**UNIVERSITY OF SYDNEY CENTRE FOR OBESITY, DIABETES AND CARDIOVASCULAR DISEASE
PROJECT (MP 09_0051) – RESPONSE TO SUBMISSIONS**

University of Sydney Centre for Obesity, Diabetes and Cardiovascular Disease Project (MP 09_0051)
Response to Submissions Table

**Major Project Application No. 09_0051
University of Sydney Centre for Obesity, Diabetes, and
Cardiovascular Disease (CODCD)
Response to Comments from City of Sydney**

Figure 1

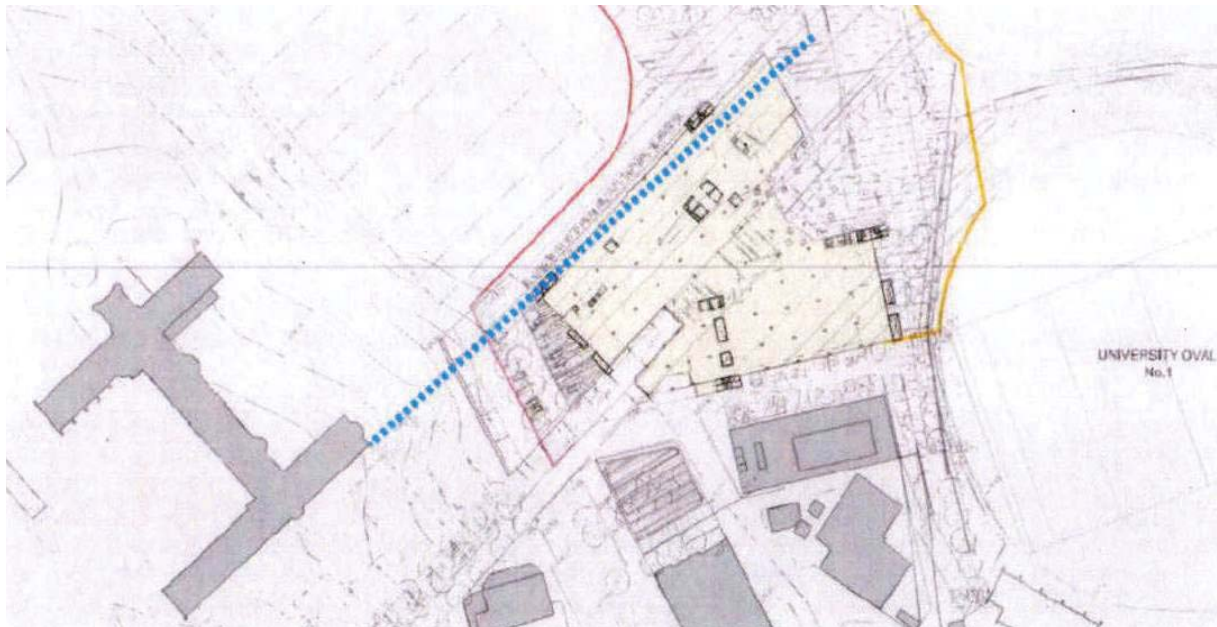
- in accordance with section 6.5 of the CMP, the building should be contained so that it does not extend west of the extended alignment of the southern most wall of the college (see Figure 1);
- a landscaped setback of at least 10m be provided between St John’s oval and the new building. Consideration should be given to whether the proposed landscape treatment is adequate (see Figure 2); and
- to reduce the bulk and scale of the building and its dominance when viewed with St John’s College, consideration should be given to reducing its height.

The proposed building has been designed to align with the southern facade of St John’s College, rather than the building setback interpreted in the City of Sydney response as being that prescribed in Section 6.5 of the *St John’s CMP*, and shown as a dashed blue line in Figure 1. The *St John’s CMP* notes the following in relation to preserving views to the Wardell Building:

As noted in the *CMP* views from the university to St John’s College are largely obscured by the existing buildings and vegetation. Although part of the proposed development is to be within the view arc

identified in the *CMP* the outcome will be an increased opportunity to view St Johns College from within the university grounds. Given the context of the increased opportunities for viewing, and appreciating, St John's College that will be generated by the active use of the area around the CODCD building as a connection to the university, the minor variation to the view corridor identified in the *CMP* will have no more than a marginal impact, which is considered acceptable and is supported.

Drawing
L-102
Public Domain Plan

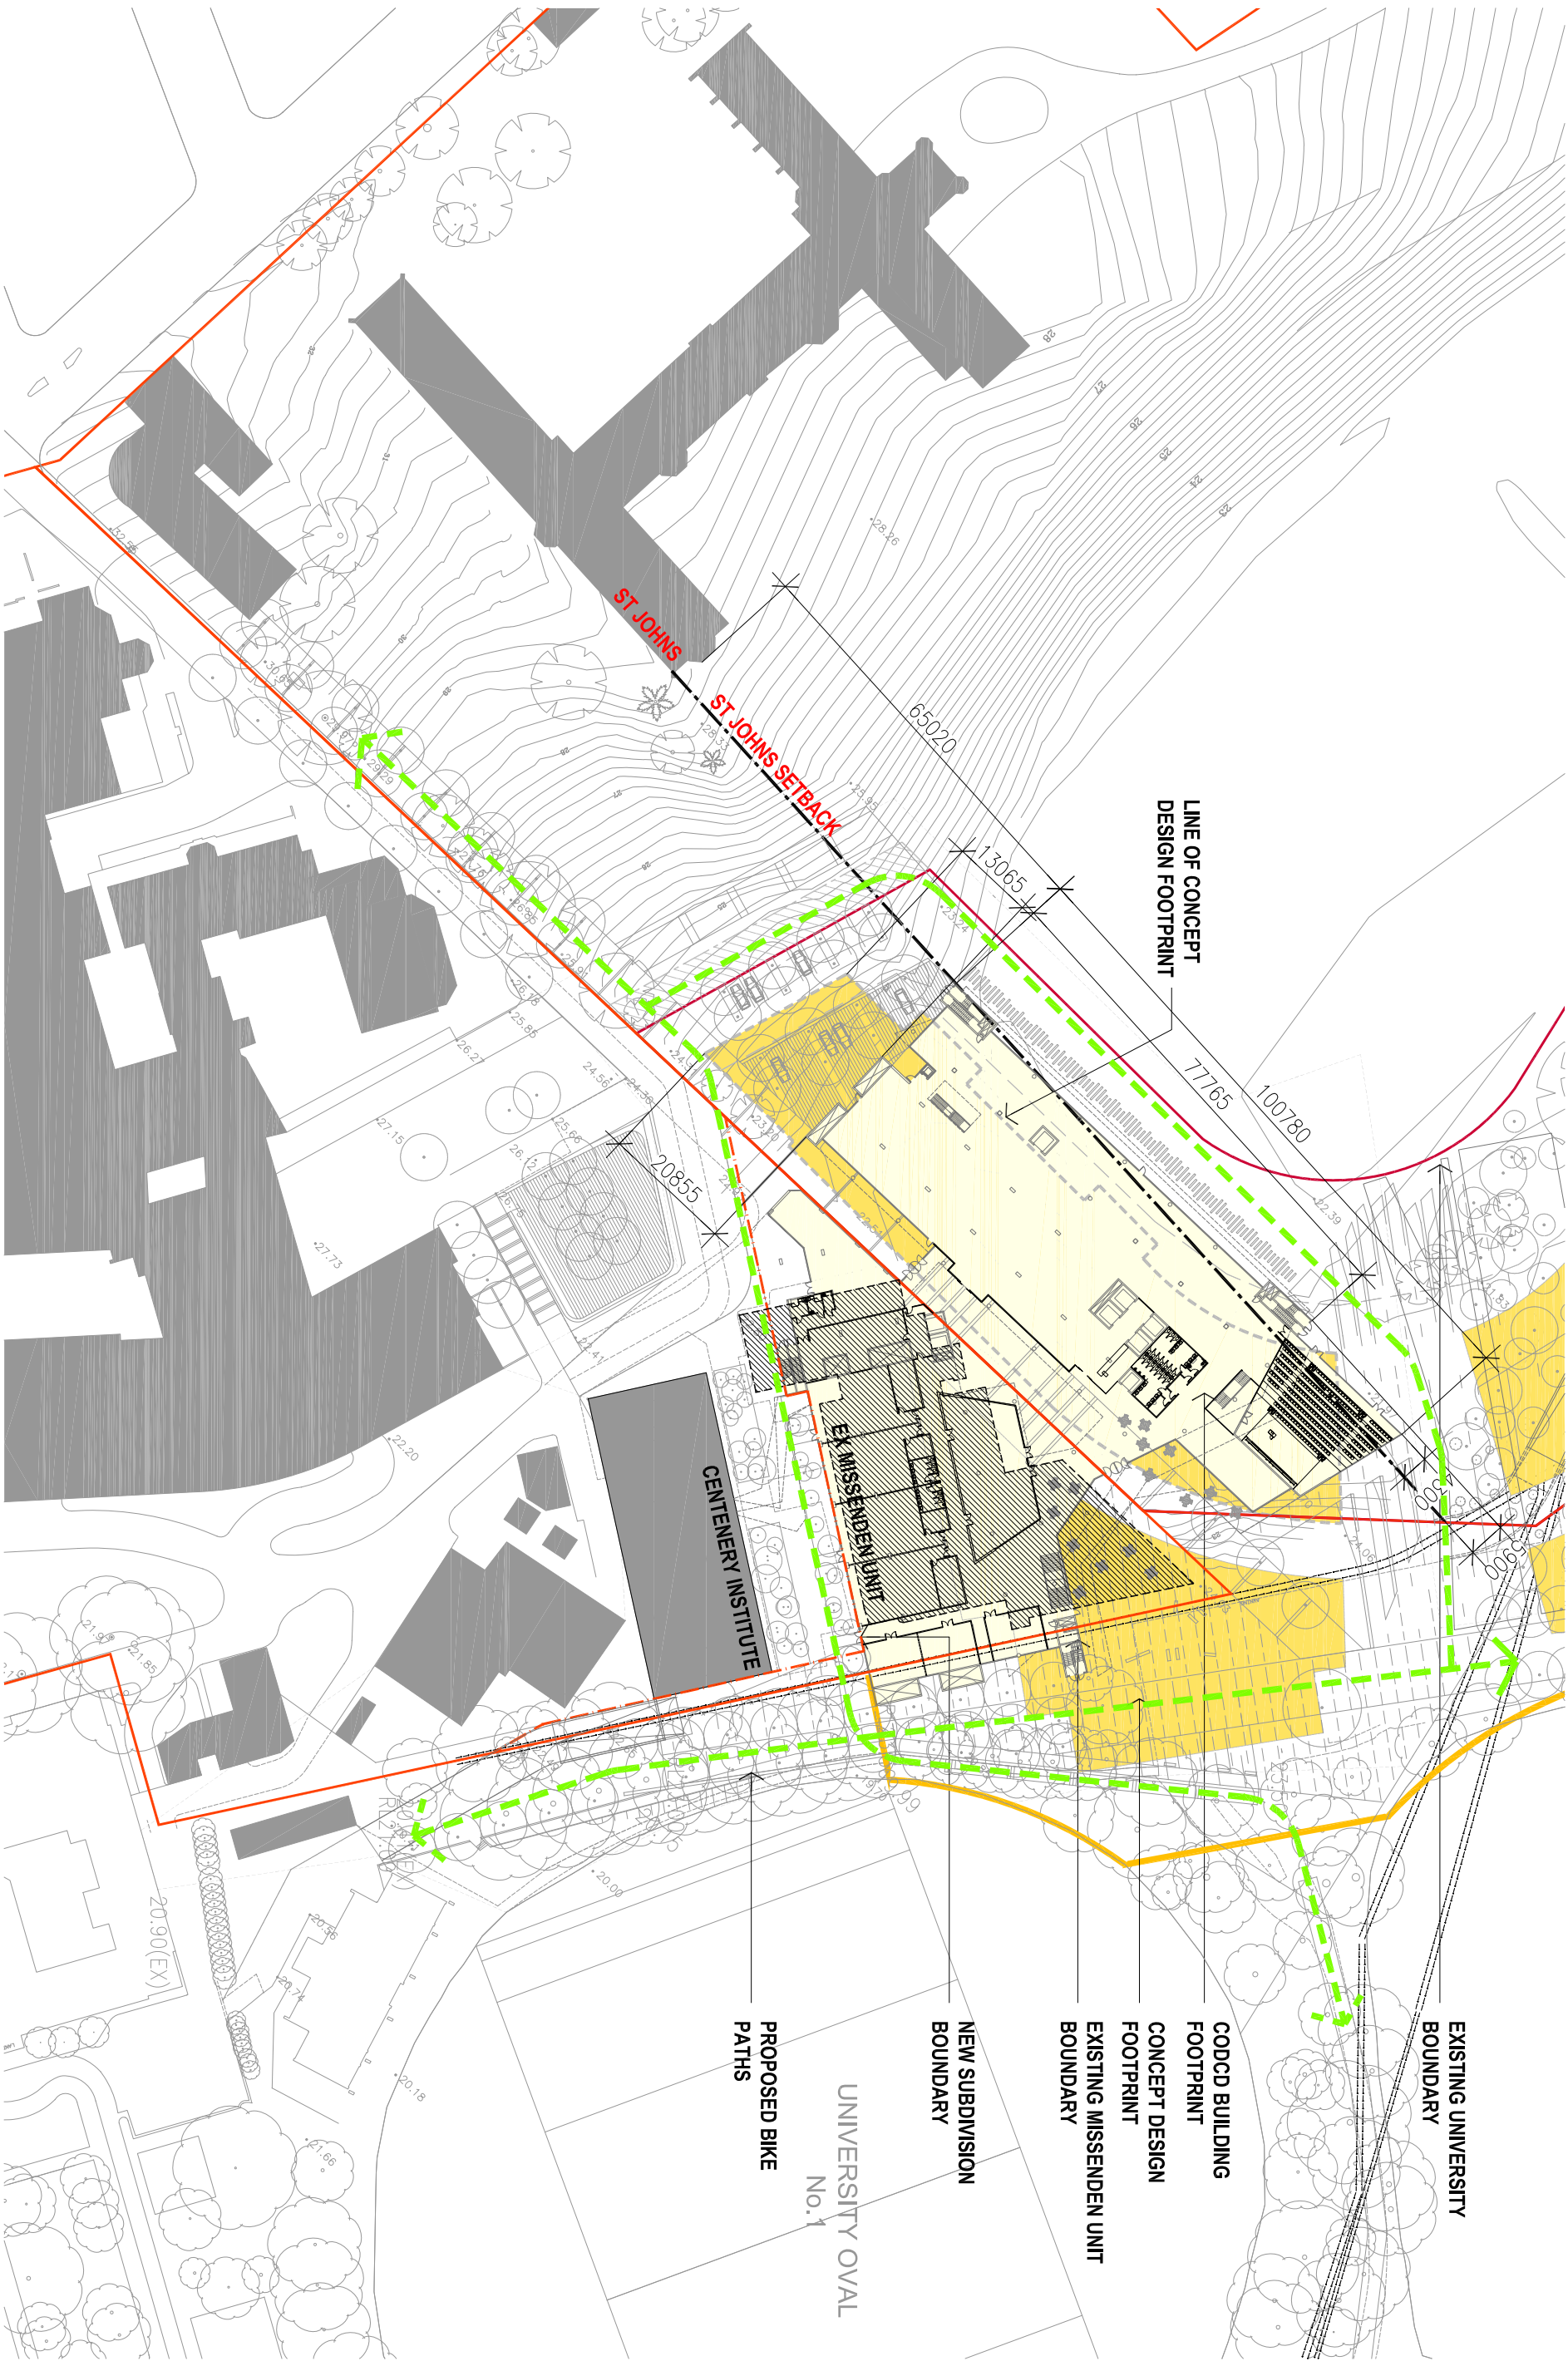
Council comments that it is not clear whether the proposed drop off/pick up spaces are on public streets or on private lands.	The University confirms that the proposed drop off/pick up parking spaces will be on private, University-owned land.	-	
<i>Bicycle Paths</i>	Council comments that the project appears to sever a proposed major bicycle route though the University that connects it with the RPA and the Missenden Road cycleway.	<p>The University acknowledges that the CODCD is located on a key pedestrian and bicycle route, as indicated in Council's submission and on Figure 6.7 of the EA (which is sourced from the University's draft <i>Campus 2020 Masterplan</i>).</p> <p>The CODCD project has been designed in a manner that respects this network, including the key provision of a ground level pedestrian link through the CODCD building from John Hopkins Drive to the existing pedestrian infrastructure between the University Ovals.</p> <p>The University acknowledges that this pedestrian link would not support safe mounted bicycle thoroughfare. However, comfortable mounted bicycle (and pedestrian) thoroughfare would be available around both sides of the CODCD building, as shown on the attached plan prepared by Hassell.</p>	Additional plan showing available bicycle access prepared. Revised Landscape Masterplan prepared showing northern bike path (see attached)

Issue Title	Issue/Recommendation	Response	Action Amendment /
		As outlined above, a revised Landscape Masterplan has also been prepared, showing the bike path around the northern side of the CODCD.	
<i>Bicycle Facilities</i>	Council notes that adequate bicycle parking (and walking) facilities should be provided in accordance with the Department of Planning's <i>Guidelines for Walking and Cycling</i> , and that secure bicycle parking should be provided on the uppermost level of the basement, on one level, close to any entry/exit points, subject to camera surveillance and accessible by a ramp.	<p>The project includes provision of approximately 125 secure bicycle parking spaces in the CODCD basement, along with a large, centrally located amenities facility (inc. showers, toilets and locker room) on Basement Level B1. The project includes a commitment in this regard (Commitment 1.3.17).</p> <p>It is noted that the proposed bicycle facilities comply with the bicycle parking facility rates in the Department's <i>Guidelines for Walking and Cycling</i>, which recommend parking spaces be provided at rates of 3-5% for staff and 5-10% for full time students. Based on these rates, the CODCD would require between 83 and 155 bike parking spaces. The proposed parking (ie. 125 spaces) is at the upper end of this range.</p>	-
